Flood Control Project Maintenance
Levee Inspections

Spring 2017 Levee Inspection Results

Knights Landing Ridge Drainage District

Waterway	Bank	Unit Miles
Unit No. 01 Knights Landing Ridge Cut	Right	6.36

Photo 1 of 3 : UCIP_SP_2017_13205_21602.jpg

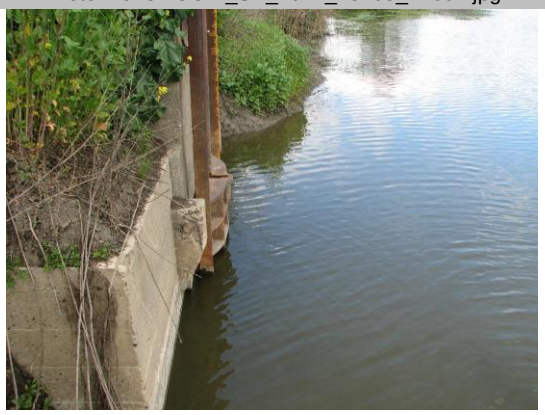
Slide gate and concrete headwall on WS toe.

FS_ID:13205
DS_ID:19391
EP_NO: 9307
Repair Type: Non-Urgent
Crossing Status: Found
UCIP Comments: Walkway to actuater slide gate is missing. No method of actuating slide gate.
FIELD_STRUCT_DESC: 2 of 2: 4-foot x 4-foot concrete box culvert through the levee, 23 feet below the crown. Walkway to slide gate on the waterside end, concrete headwalls on both ends. Service pole and anchor at landward toe. Concrete headwalls on both ends (Permit No. 9307- Lowe).
FS Date: 4/5/2013

Photo 1 of 1 : SP_2017_NA0008_257_15_20170502_00027.jpg

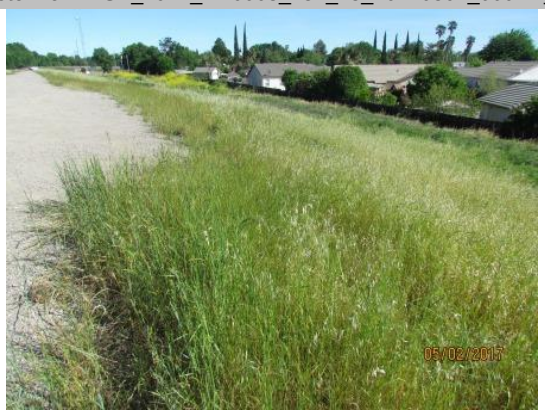
Tall grass on landside levee slope, blocking visibility. Spring 2017.
